**ZONING AMENDMENT,
PLANNED UNIT DEVELOPMENT &
SUBDIVISION STAFF REPORT**

Date: June 1, 2006

NAME River 4 Properties L.L.C.
LOCATION 4061 Hillcrest Lane West
South side of Hillcrest Lane West at Pansy Court (private street)

CONTEMPLATED USE Rezoning from R-1, Single-Family Residential district, to R-3, Multi-Family Residential district, to allow residential condominiums, and Planned Unit Development Approval to allow multiple buildings on a single building site.
It should be noted, however, that any use permitted in the proposed district would be allowed at this location if the zoning is changed. Furthermore, the Planning Commission may consider zoning classifications other than that sought by the applicant for this property.

SITE PLAN

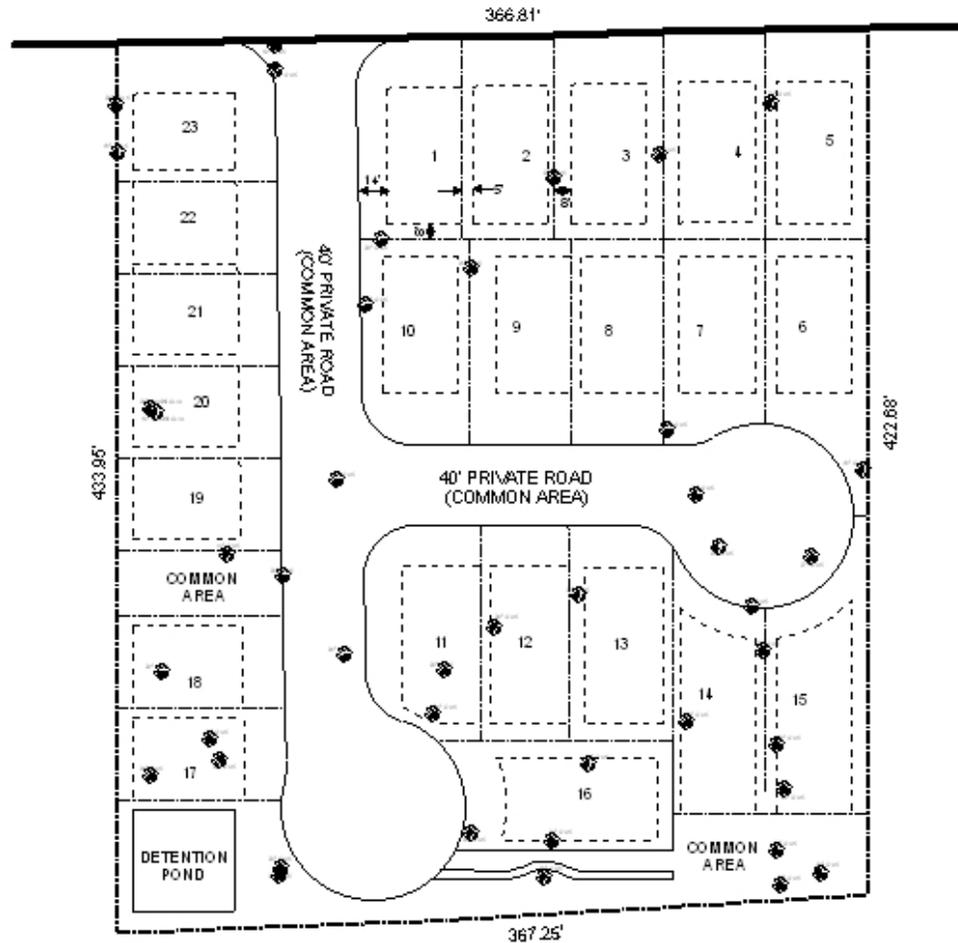
Conceptually, the development depicted on the proposed site/layout plan will minimize impacts to the surrounding residential development, especially with the proposed common area along the Southern boundary of the site. It should be noted, however, that there is no indication on the site plan regarding the perimeter treatment of the property; specifically if a fence and/or landscape buffer will be provided to minimize impacts to adjacent lower-density residential developments. A privacy fence and landscape buffer is recommended for development on the West, East and South property lines. Furthermore, generalized landscaping proposed for the common areas should be depicted on the site plan, with the understanding that final landscape plan will be more detailed and require approval by the Urban Forester.

The vehicular circulation system depicts a 40-foot wide private right-of-way, with a pavement width of less than 20 feet, and a cul-de-sac diameter of 80 feet. Section V.B.15. of the Subdivision Regulations requires a minimum pavement width of 26 feet, thus the site plan should be revised to depict the minimum required width. The intersection of the private road with West Hillcrest Lane should include a minimum curb radius of 20 feet. The sidewalks, as depicted, meet minimum width requirements.

The site plan additionally appears to indicate that each “building site” will have the equivalent of a “lot” that is associated with the “building site.” As a condominium development, all land area is owned by the condominium governing board: there are no individual lots. Therefore, the site plan should be revised to remove the “lot” lines, however the “building site” areas may remain as depicted.

A detention basin is proposed for the site. A note should be placed on the site plan, if approved, stating that maintenance of the detention basin common area, and any other common areas, are the responsibility of the development's property owners.

Finally, the minimum building setback line required in Section V.D.9. of the Subdivision Regulations is not shown for the overall lot, but would be required on the Final Plat.

Planned Unit Development: *The PUD request is recommended for Holdover until the July 20th meeting, for the following reasons: 1) revision of the site plan to depict the minimum required pavement width and curb radii; 2) revision of the site plan to remove the "lot" lines; and 3) revision of the site plan to depict fence and landscape buffering along the East, South and West property lines that complies with Section 64-4.D. of the Zoning Ordinance. The revised site plan should be provided to Urban Development by June 27th.*
